**REQUEST FOR WAIVER FROM ACCESSIBILITY REQUIREMENTS  
OF CHAPTER 553, PART V, FLORIDA STATUTES**

Name: Chi Omega Sorority House

Re: Response to 2<sup>nd</sup> Plan Review Comments for  
Chi Omega Dining Room Expansion  
611 West Jefferson Street  
Tallahassee, FL 32303

**Sheet** S3.0

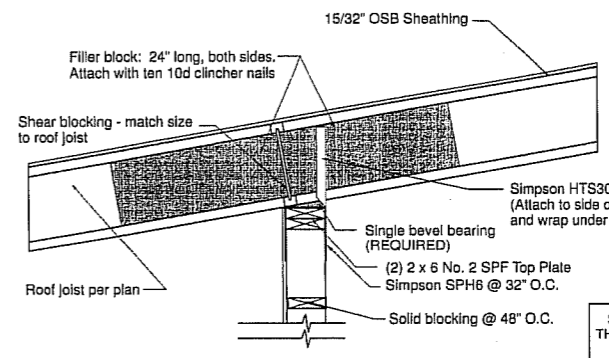
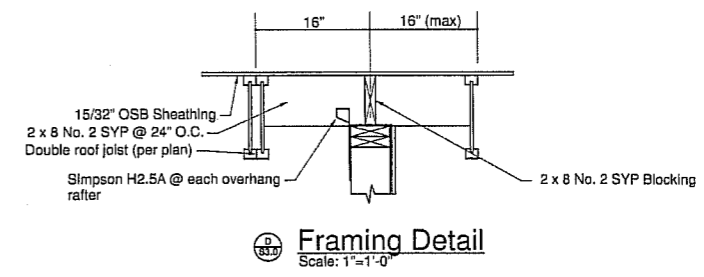
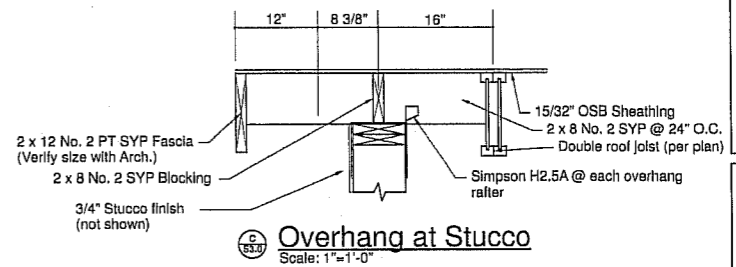
- 10) Revise Sections D/S2.0 and A/S3.0 to provide complete sections showing new and existing construction. ***Notes for Ledger Detail B/S3.0 indicate Titen HD bolts for wood construction; however these bolts are for masonry construction. Please provide another fastener.***

*Response: Complied, see response provided per Sound Structures Engineering, Inc., and revised sheet S3.0, attached.*

COMMENTS: **SHT E0.1**  
 DATE: **5-16-11** APPROVED BY: **[Signature]**

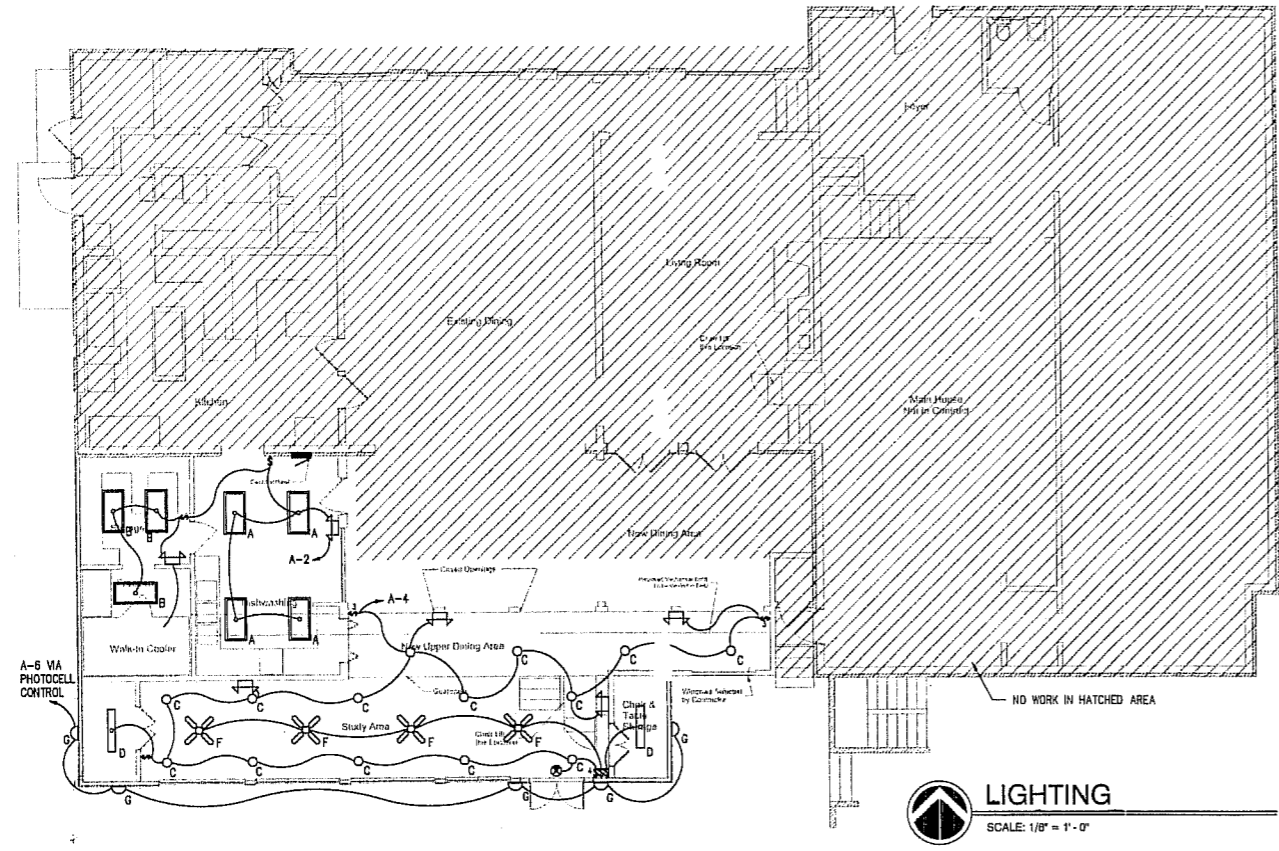
3.) *Sheet E1.1 redlined to revise Work Notes A and C to indicate 2 - #4 Cu with 1- #8 Cu gnd.*

*Response: Redline acknowledged, no further action required.*

1 Floor Plan  
Scale: 1/4" = 1'-0"

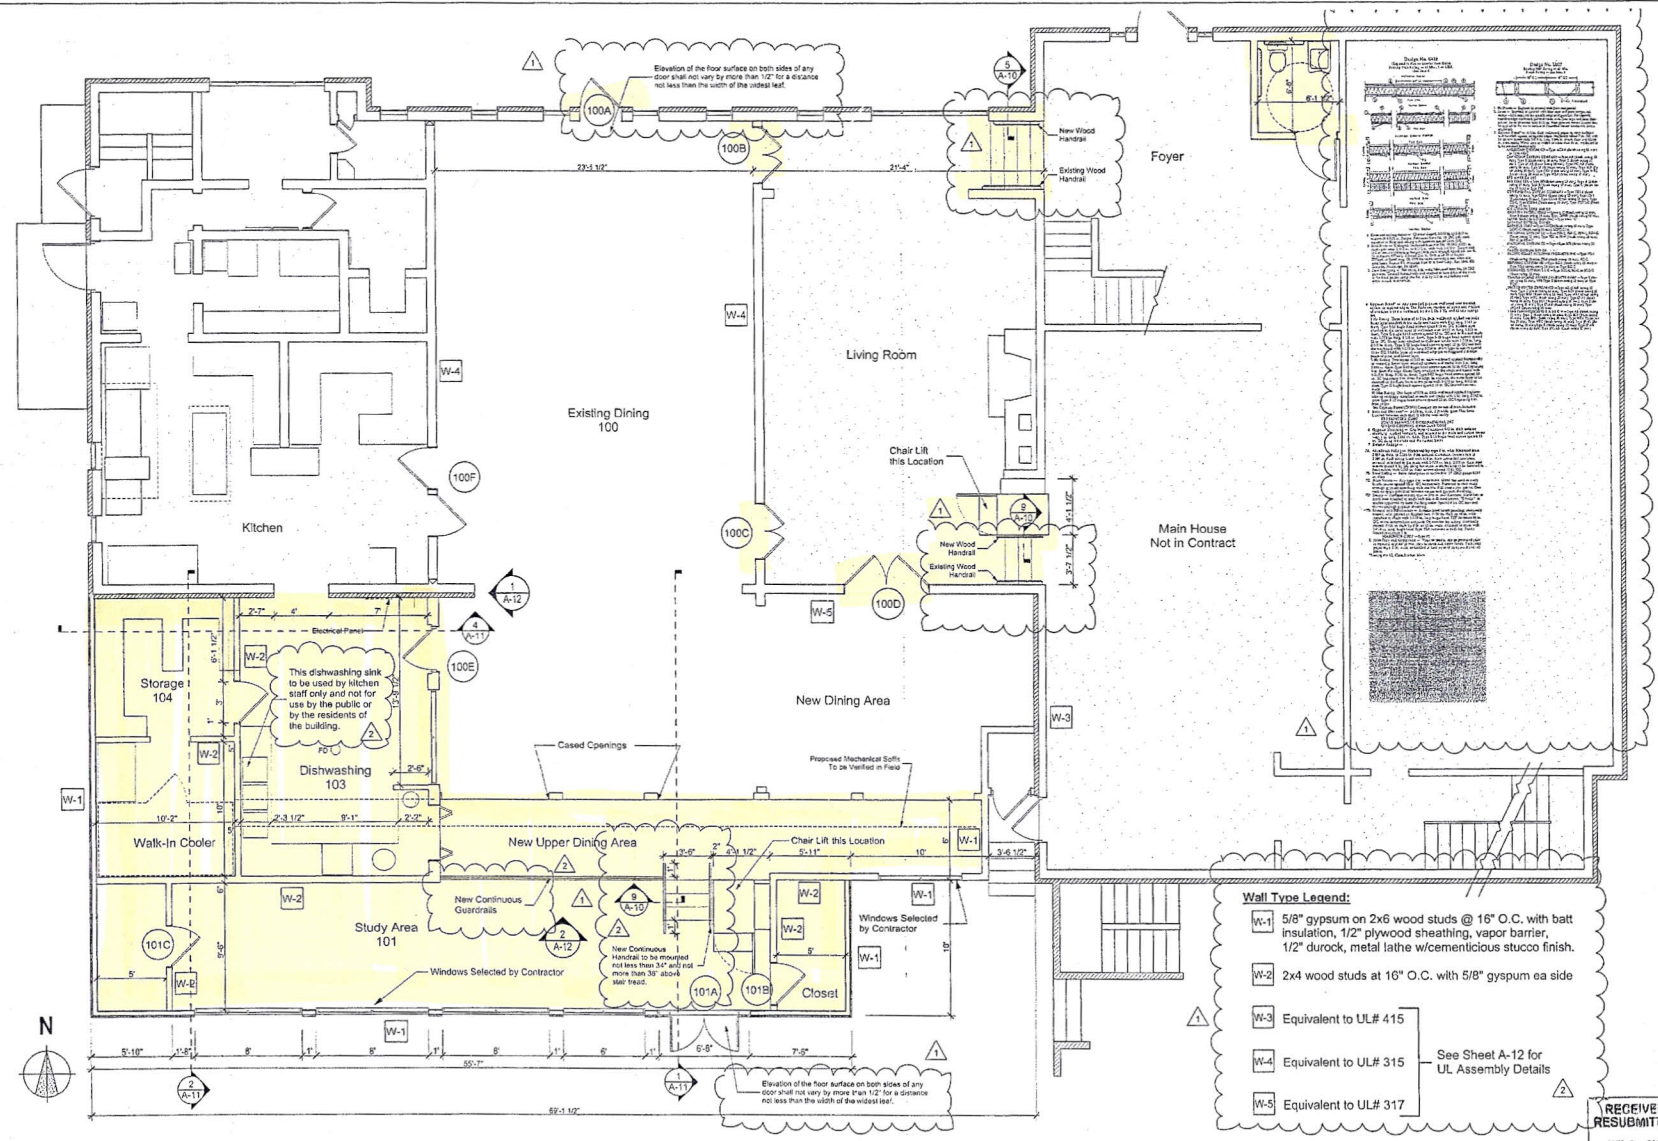
- c. ***Per Section 1012.4 FBC-B, handrail-gripping surfaces shall be continuous, without interruption by newel posts or other obstructions. Provide detail specific to this stair and revise plans to clearly illustrate compliance with this section.***

*Response: Complied, see revised sheet A-8 and A-10, attached.*

4 Stair Detail  
Scale: 3/4" = 1'-0"

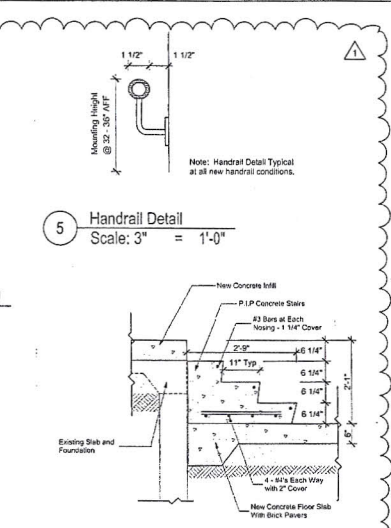
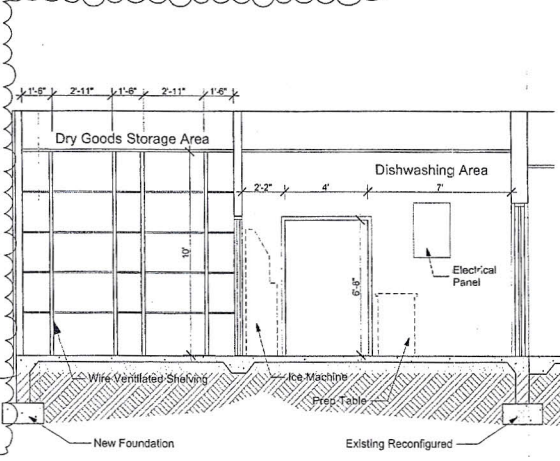
- b. ***Provide handrail detail specific to this stair showing handrail height, measured above stair tread nosings, not less than 34 inches and not more than 38 inches per Section 1012.2 FBC-B.***

*Response: Complied, see detail 9/A-10, attached.*
